KAW VALLEY ENGINEERING, INC.

RE: WALGREENS
SW 29th STREET AND SW GAGE BOULEVARD
TOPEKA, KANSAS

On the behalf of Batis Development Company, Kaw Valley Engineering, Inc. (KVE) has reviewed the comments from Coder Engineering dated May 13, 2014 on the Traffic Impact Study for the proposed Walgreens on the northwest corner of 29th and Gage Boulevard. KVE is issuing an Addendum to the Traffic Impact Study dated April 17, 2014 in response to the comments.

Job No. 057-13-002 (T)
Date 5-13-14	Sheet 1 of 2
Project 29th & Gage Walgreens	By TLC
Subject TIA and Plat Review	Ck'd

FIGURE "6"
WALGREENS
TOPEKA, KANSAS
EXISTING PLUS PROPOSED CONDITIONS
AM AND PM TRAFFIC
VOLUME/DISTRIBUTION DIAGRAM
WITH RECOMMENDED IMPROVEMENTS
SCALE: N.T.S.
FIGURE-05.dwg

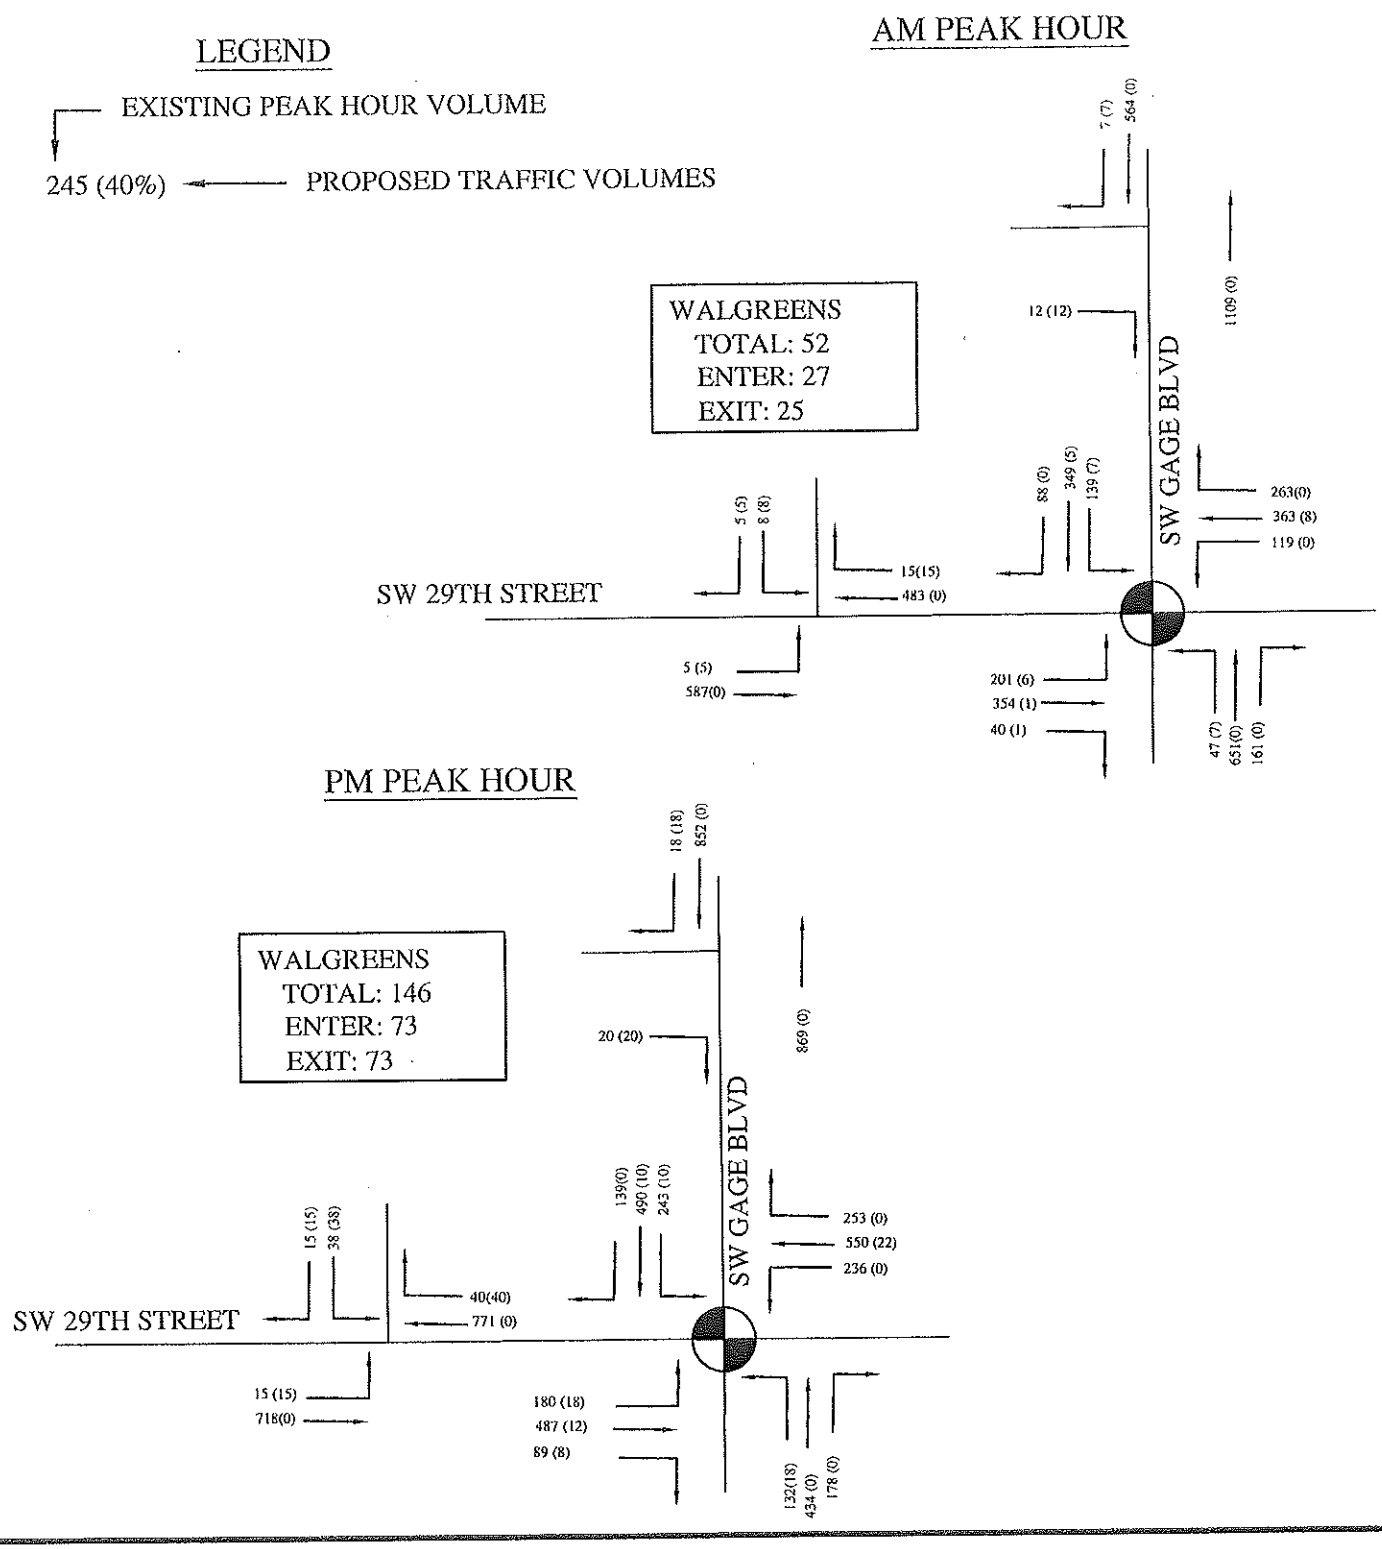
3. The TIA provides capacity and queing analysis for all movements (left and right out) at both entrances. However the TIA recommends consideration of "Right in/Right Out Only" at the north entrance. Analysis of the entrance operation should be completed for the recommended configuration to access the impact additional exiting traffic will have on the operation of the west entrance.

4. The TIA recommends consideration of making the north entrance (SW Gage Blvd.) Right in/Right Out Only. The drawing show a left turn out being available.

2. Limiting traffic to right in and right out will cause a shift in traffic demand from the north driveway to the west driveway as illustrated on the Proposed AM and PM Peak Hour traffic volume diagram with Recommended Improvements (Figure 6). To document the impacts on the adjacent street network, the Capacity and Queuing analysis for the study intersections has been revaluated. The results of the capacity analysis for the proposed AM and PM peak hours are summarized in Table 8.

The results of the analysis for proposed conditions indicate that a north driveway with limited access will have minimal impact on delay and queuing at the adjacent signalized intersection at 29th and Gage Boulevard. A small increase in average delay per vehicle should be expected at the west driveway, but the driveway should operate at a Level of Service E or better. The longest delay would be for the left turn movement.
